In view of the fact that Telefunken quite some time ago discontinued manufacture of the VF 14 tube used in the U 47 and U 48 microphones, Neumann has devised a means of converting these microphones from the VF 14 tube to another tube. Due to the fact that no completely equivalent tube is available on today's market, the following changes have to be made:

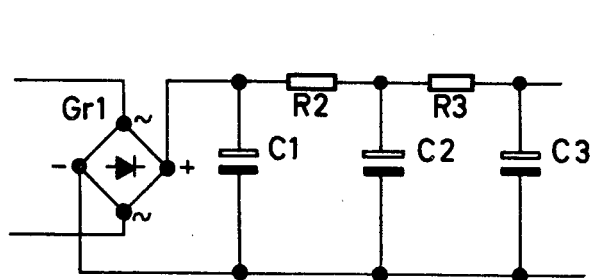
1. Remove VF 14.
2. Remove the leads (red, blue, yellow, green, black) from the tube holder (at U 48 remove also 29- Ω -resistor.).
3. Remove the tube holder after unscrewing six screws in the three bars.
4. Two of the three plastic holders supplied have to be inserted into the screw holes.
5. Put the AR 47 upside down into these holders and fix it by inserting the third plastic holder. (The AR 47 side with three soldering points shows towards the front of the microphone.)
6. Resolder the leads according to the sketch below (at U 48 resolder also the 29- Ω -resistor).
7. Insert nuvistor 13 CW 4 into the socket.

NG power supply schematic:

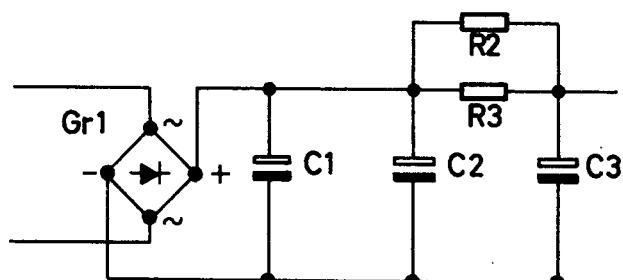
The NG pwr supply must have a small change of wiring due to the greater heater current required by the nuvistor.

- a) Replace resistor R-2 (1 k Ω power resistor coming from + terminal of rectifier) by a solid wire connection between the first two electrolytic capacitors.
- b) Install this same R-2 in parallel with R-3 (an identical resistor next in the RC filter chain), thereby making its total resistance value 500 Ω .
